Re: Parklawn Self Storage
Local Map Amendment H-154
MHG Project No. 2023.193.21

The following is a point-by-point response letter to the comments provided on August 12, 2024, by The Montgomery County Staff for the Parklawn Self Storage Local Map Amendment, application number H-154.

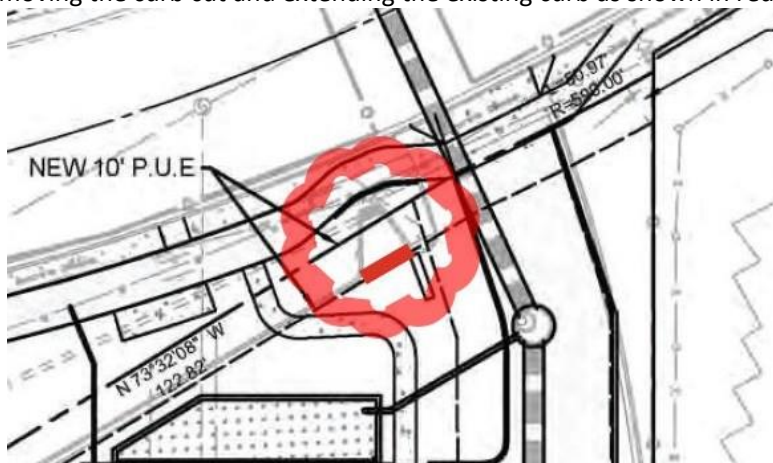
21. The existing inlet is in the right-of-way and should be relocated into private property by removing the curb cut and extending the existing curb as shown in red below.

Response: The existing drainage structure has been replaced with a new trench drain structure.
